PR/0375/22

Record of Executive Business and Chief Executive's Order

Reg. Reference: SD21A/0186 **Application Date:** 05-Jul-2021
Submission Type: Clarification of **Registration Date:** 25-Feb-2022
Additional
Information

Location: Plot 100, Profile Park, Nangor Road, Clondalkin, Dublin 22

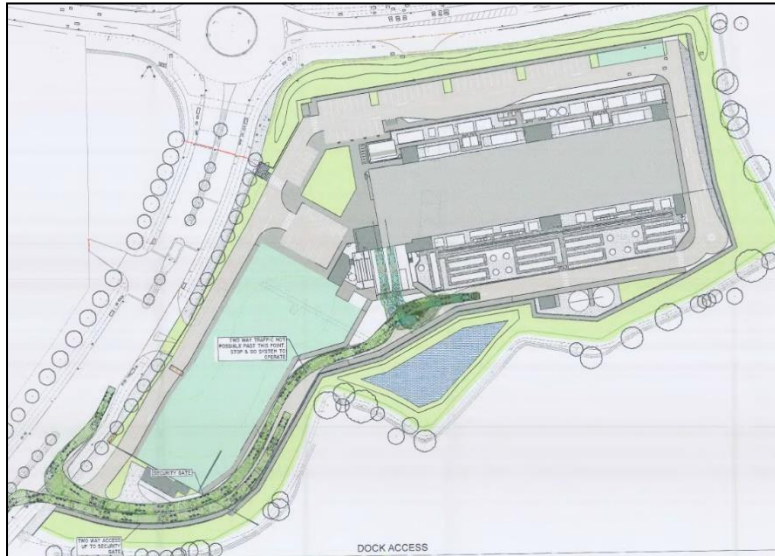
The main access road through the proposed development is to be widened to 10.8m wide while the rest of the roads around the development range in width between 4.5m-7.5m. The road into the perpendicular car parking bays is over 6.0m wide this is adequate space for reversing. A separate HGVs road through the main access along the south eastern boundary of the proposed development towards the deliveries yard at some location the width of the road is proposed to be 4.5m two-way traffic not possible at this point it is proposed to operate Stop & Go system.

Multiple Auto track analysis were submitted for different types of HGVs and trucks, the internal junction radii are shown to be adequate to accommodate these types of trucks.
